# Picton High School

## Proposed Roadworks Road Safety Audit

Version: 01

Date: 5/09/2018

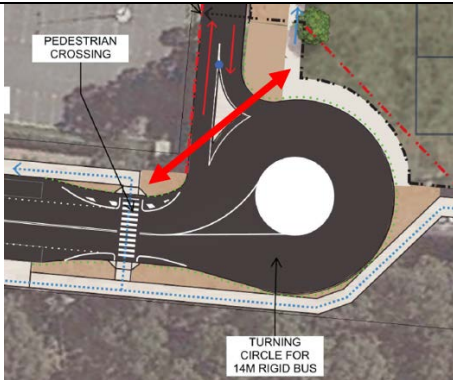
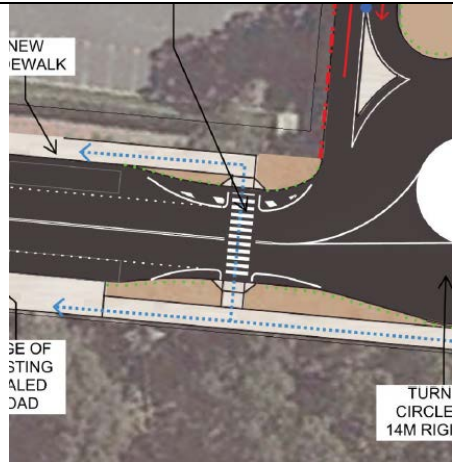
Item No.	Descriptions of Findings	Photo	Likelihood	Severity	Risk Rating
1.	<p>All pedestrians walking along Argyle Street will need to divert into the site due to the 1200mm fence barriers and the removal of the footpath between the access/egress. Pedestrians may not be sure if they are trespassing into private land owned by the school. Consequently, pedestrians may walk into the road outside the fence which has potential for collisions with vehicles.</p> <p>N.B. The plans are not consistent – the Traffic &amp; Security Design shows the footpath between the entrance / exit retained whilst the Site Context Plan shows this footpath replaced with a wider verge and no footpath but shows no fence.</p>				
2	<p>Provision of a 70m right turn bay for the Argyle Street to School Bus Interchange right turn movement and a new wide painted median in Argyle Street results in the removal of a number of 2 minute on-street parking spaces on the west side of Argyle Street.</p> <p>These car spaces are currently used by parents to drop off and pick up students.</p> <p>Insufficient parking supply may result in motorists' parking/ stopping in unsafe locations.</p>		Occasional	Moderate	Medium

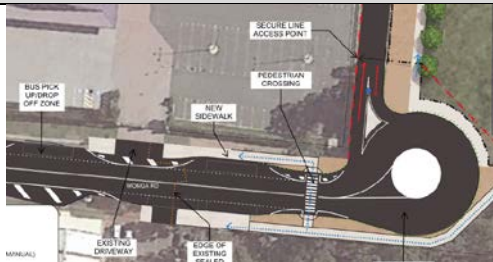
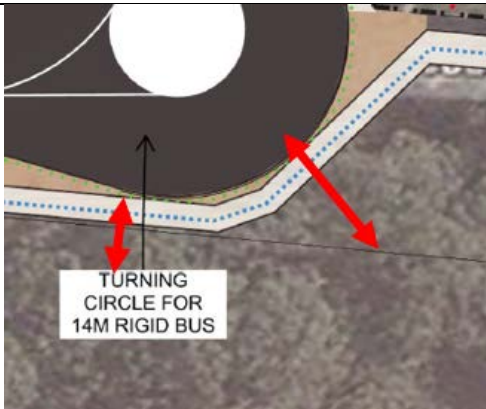
Item No.	Descriptions of Findings	Photo	Likelihood	Severity	Risk Rating
3	<p>Observations have shown that motorists often give priority to pedestrians at the existing pedestrian refuge across Argyle Street which may result in some students becoming conditioned to receiving priority. This may not always be the case resulting in pedestrian conflicts</p> <p>Consideration should be given to other pedestrian crossing treatments where pedestrians have priority over motorist.</p>		Highly Probable	Moderate	High
